Your Ref: (5) in EP2/H4/S3/15 Pt. 41  
Our Ref: H2613-LJV-EN-LE-4006

**Contract No. HY/2011/08**  
**Central-Wan Chai Bypass – Tunnel Buildings, Systems and Fittings, and Works**  
**Associated with Tunnel Commissioning**  
**Construction Noise Management Plan (Rev. 4)**

**Construction Noise Management Plan**

HKAPA

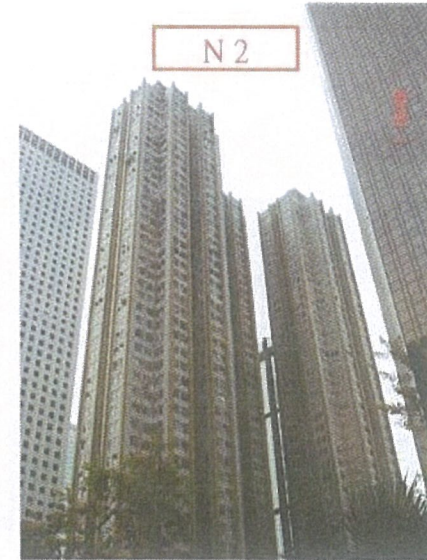
d.	RtC item h & Appendix C – The amphitheatre in HKAPA (i.e. open arena in the EIA report) has been provided with central air-conditioning and fully enclosed since 2010. It will not rely on opened windows for ventilation. The photo of HKAPA and its caption were outdated. Similar comment has been given before.	Noted. The photo has been updated.

Figure 2: Location of Temporary Noise Barriers during Construction Phase in North Point Waterfront  
圖 2: 在北角海旁施工期間的臨時隔音屏障位置圖

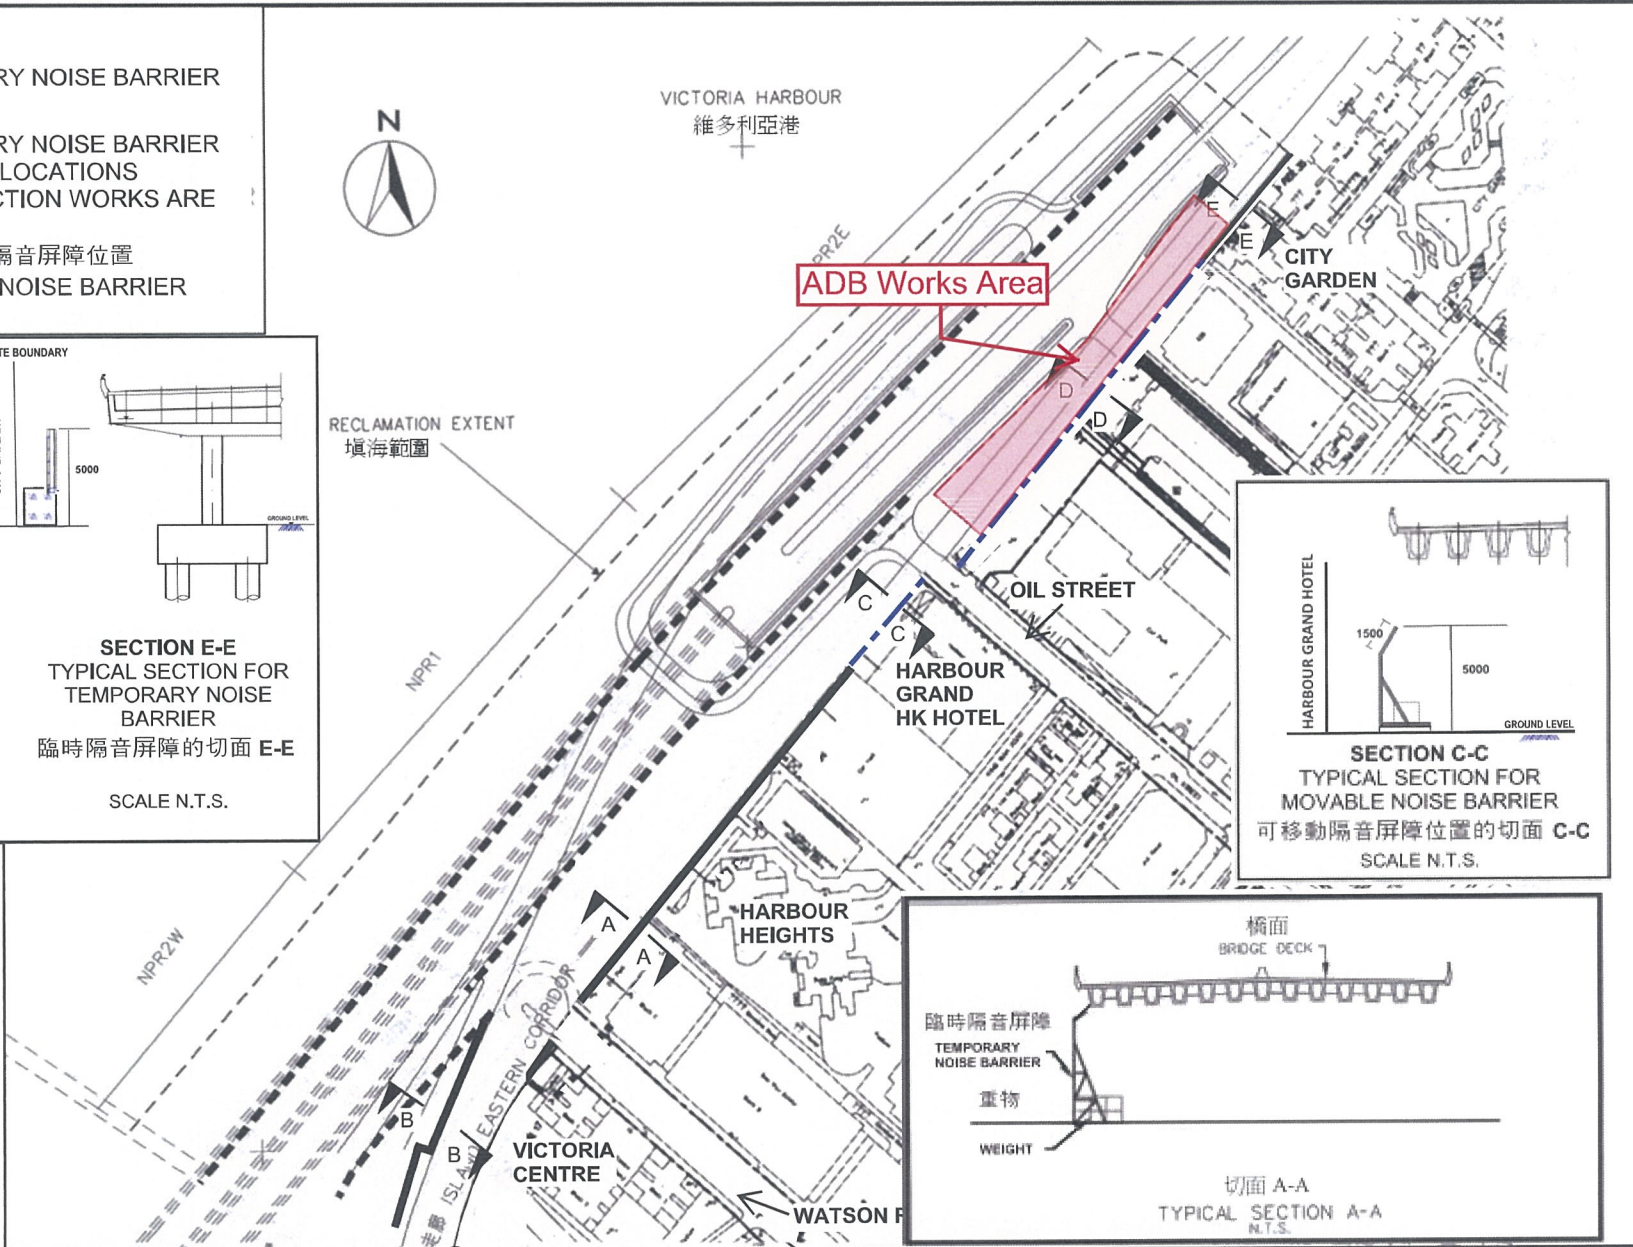
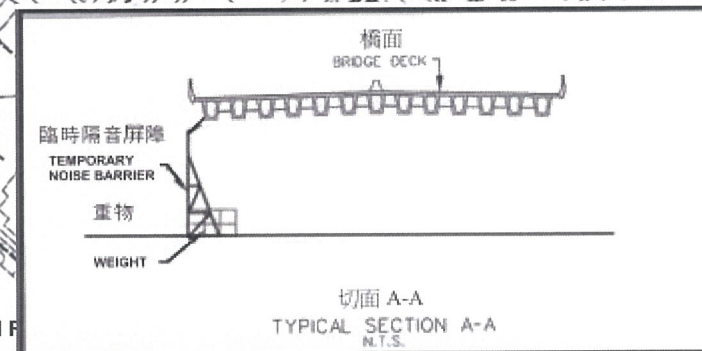
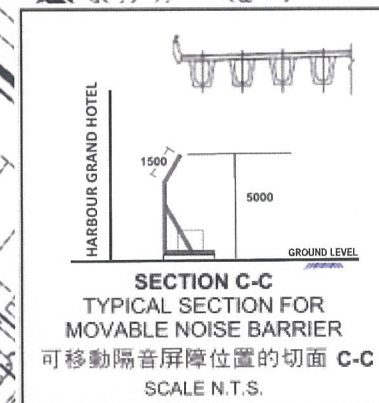
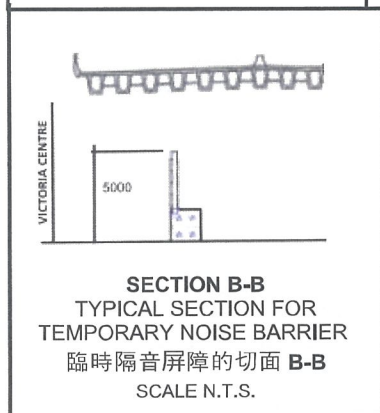
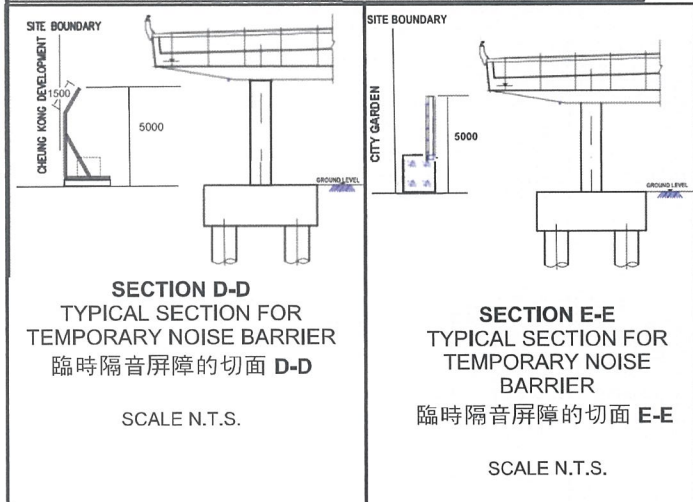
a.	Satisfactory proposal of noise mitigation measures, which are recommended in the approved EIA report and required in Condition 2.9, was found neither in the past versions nor in the current version of the CNMP. For example, details, with photos, typical plans and sections where appropriate, on the use of movable/temporary noise barriers, the use of quiet powered mechanical equipment items and the adoption of multiple-phase construction schedules in the EIA report should be given in the CNMP.	Noted. The current submission has mentioned such kind of noise mitigation measures.

- 4.1.2 During the construction of the ADB, LJV will work behind temporary noise barriers. The design and the location of them are attached in **Appendix 4A**. Hence, the temporary noise barriers will be maintained until end of 2017 and covers the tentative completion date of the ADB in August 2017.
- 4.1.3 During the construction of the ADB, LJV will employ a crane lorry (gross vehicle weight  $\leq 38$  tonne) / a QPME mobile crane for lifting operation. The photo and the QPME labels for the QPME mobile crane are attached in **Appendix 4B**.
- 4.1.4 LJV will employ quieter electric vibratory pokers for the replacement of diesel vibratory pokers. In addition, quieter electric hand-tools will be used for the replacement of pneumatic hand-tools to avoid the use of air compressors.
- 4.1.5 LJV will employ quieter electric submersible water pumps for the replacement of electric water pumps.
